From: 747 New Hey Road, HD3 3YL.
Re. Planning application no. 20236291173W, 749 New Hey Road

Photo 1: Damage to my front wall from the horse box, about 1986.

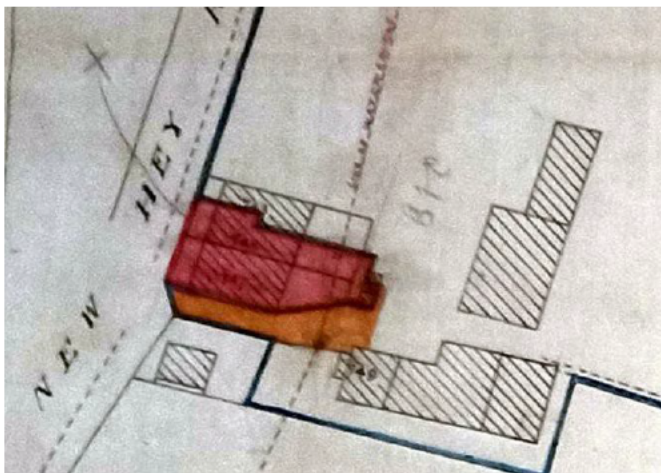
As the owner of the house immediately adjacent to the lane leading to 749 I will be delighted to see the farmhouse improved but am very concerned about the higher volume of traffic that would be using the lane if the number of dwellings is increased. It is very narrow (3.2m) and totally unsuitable for use by any more than a few cars, let alone construction and delivery vehicles and the extra cars that will come with an increased number of residents. Many years ago the then owner of 749 used to drive a horse box up and down the lane and struck both my front and rear walls on several occasions (an example in Photo 1, which I have mentioned in a solicitor's letter). I'm also concerned about possible structural damage to my large gable end wall. As well as by direct impact, large heavy vehicles could cause movement that will affect the foundations of my wall. On the inside of the wall below ground level it is not solid but mostly cellar area. Simply resurfacing the lane will not make it capable of supporting many tonnes. Raising the level of the lane will cover two air bricks that are needed to ventilate my cellar.
